CITY OF ALBUQUERQUE

RE: **Lot 24 Block 8 Unit 22 SAD 228
6301 Petirrojo Rd. NW
Volcano Cliffs Subdivision
Grading and Drainage Plan
Engineers Stamp Date 12/31/2020 (D10D003E24)**

Based upon the information provided in your submittal received 1/4/2021, this plan is approved for Grading Permit.

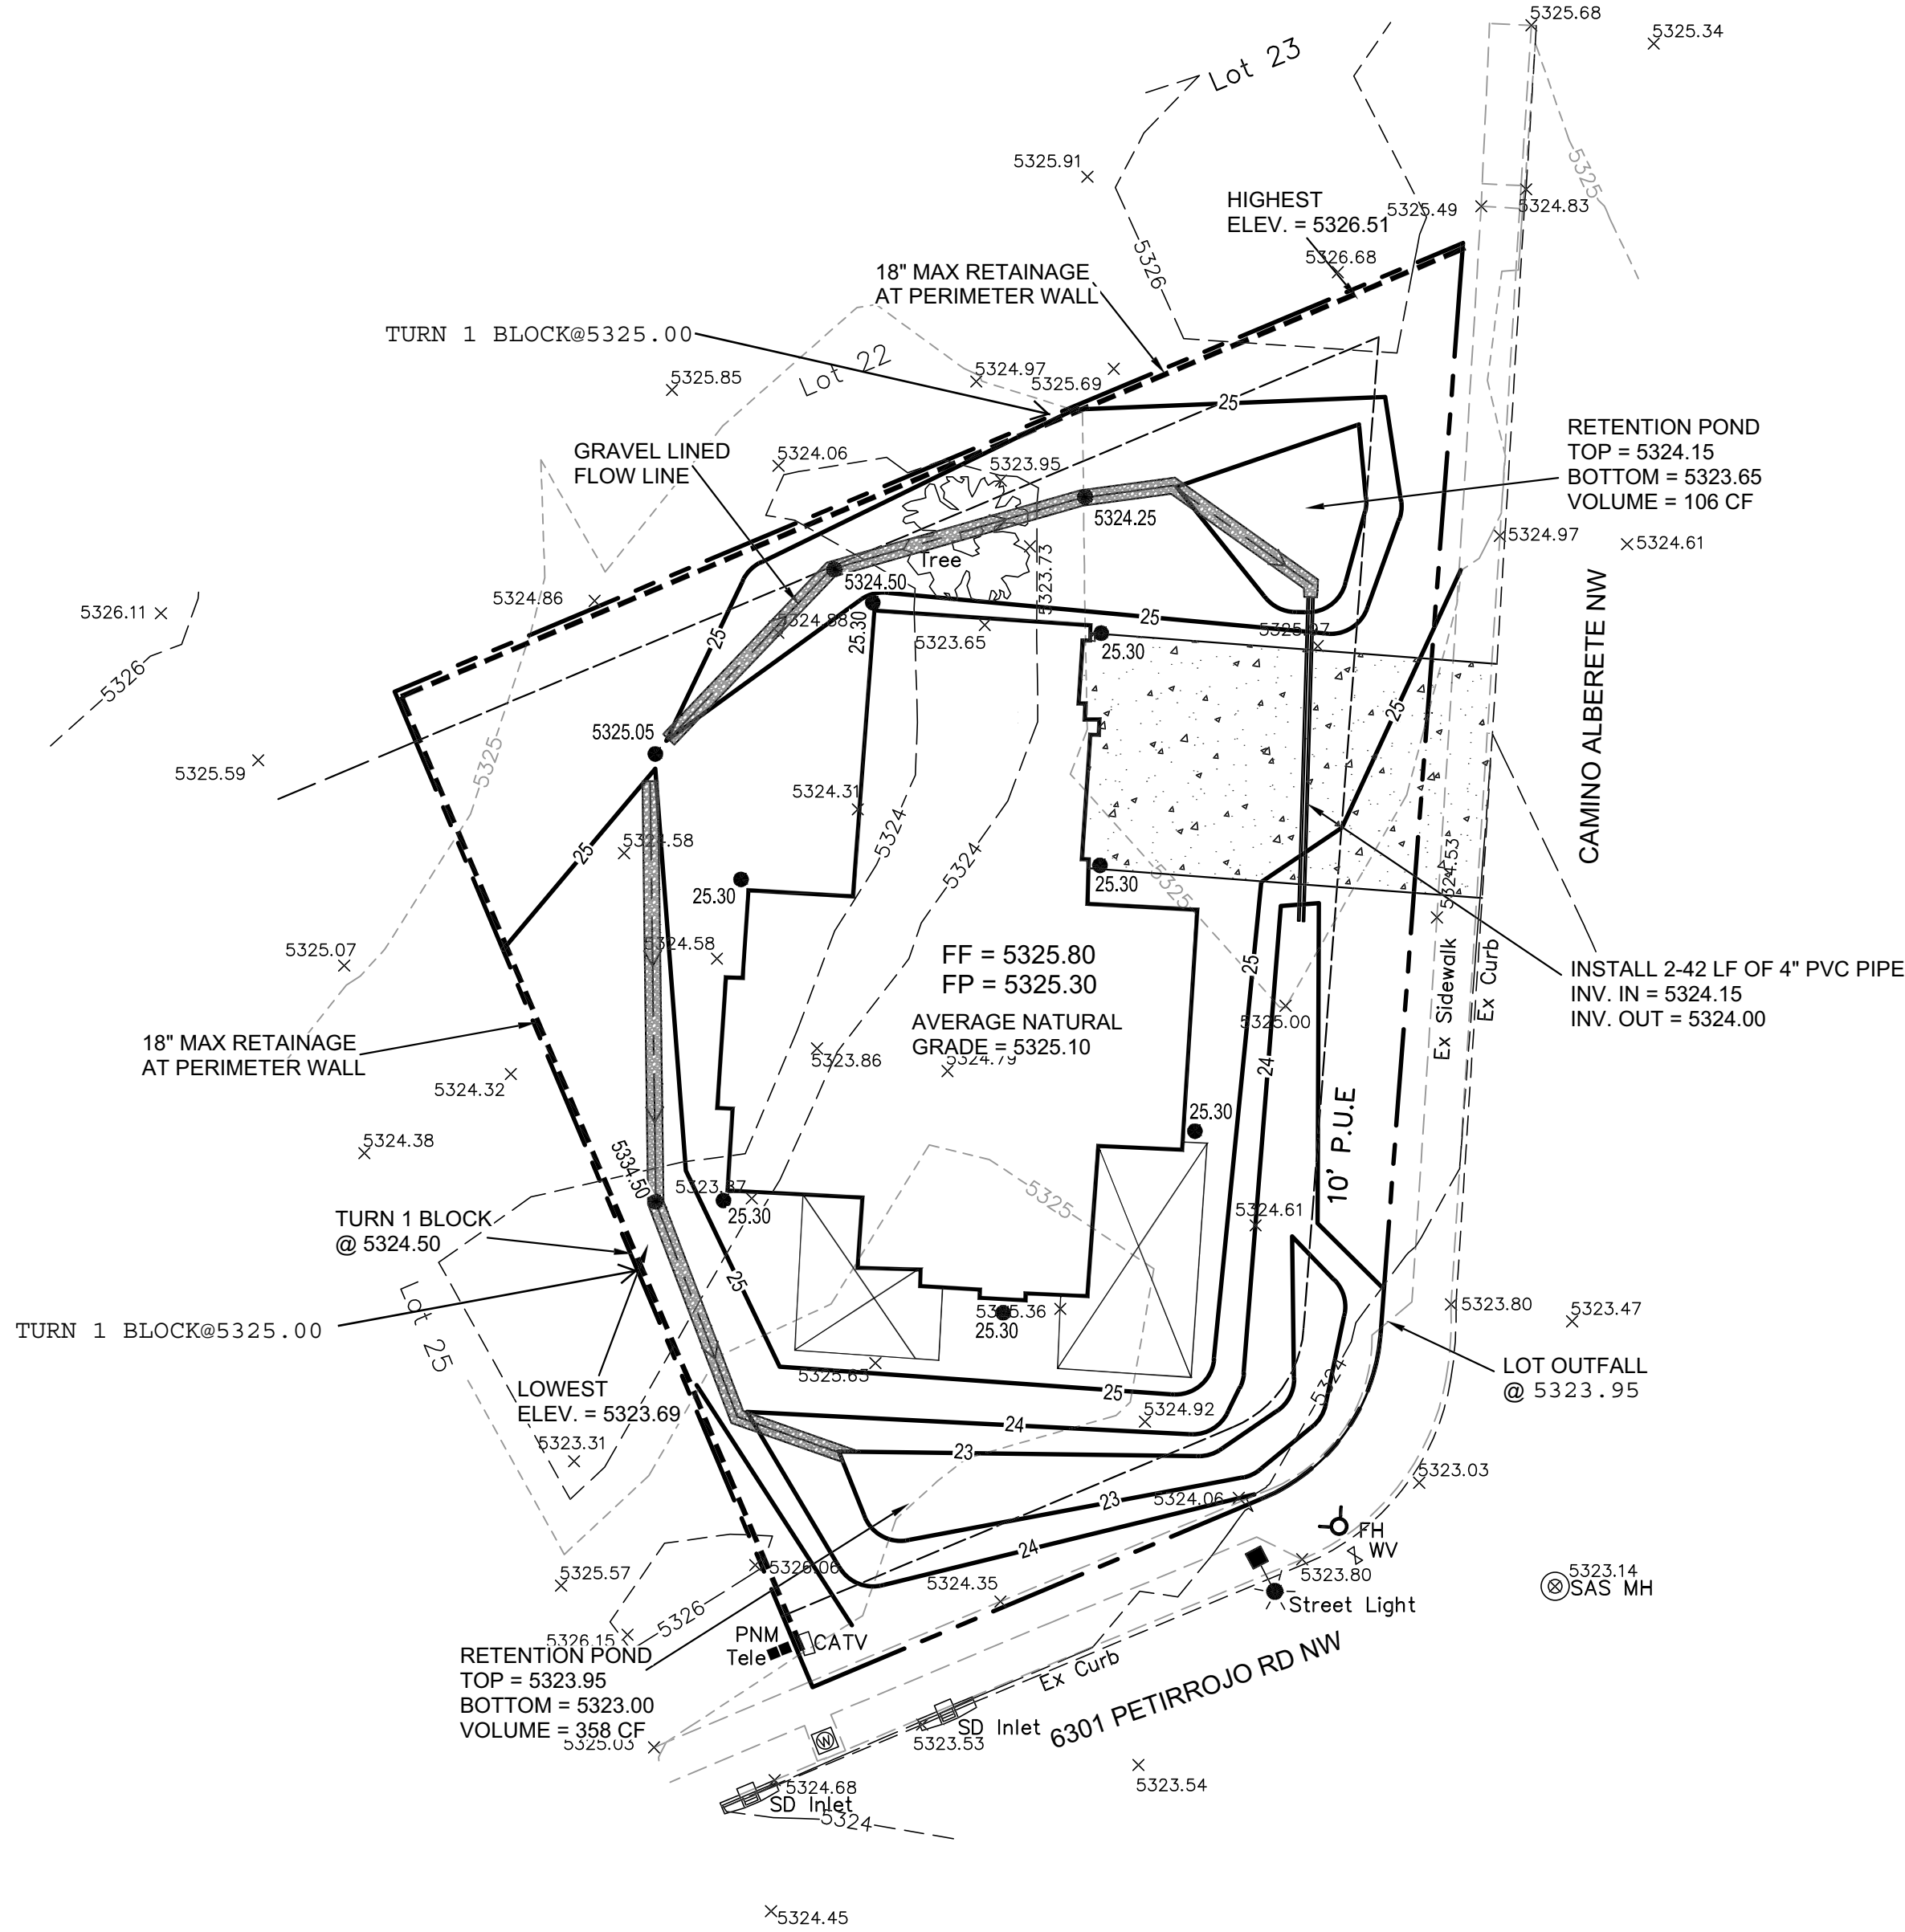
Prior to Building permit approval a Pad Certification will be required, provided by the Engineer or a registered Land Surveyor.

Advise the owner contractor not to use dirt as a ramp to climb the curb, use lumber or crusher fines for this purpose.

Reiterate to the Owner/Contractor that a separate permit for a garden/retaining wall must be obtained with the approved G&D plan and Pad Certification. Also, if a swimming pool is to be placed the grading and drainage plan will change and will need to be resubmitted.

Prior to Certificate of Occupancy release, Engineer Certification per the DPM checklist is required.
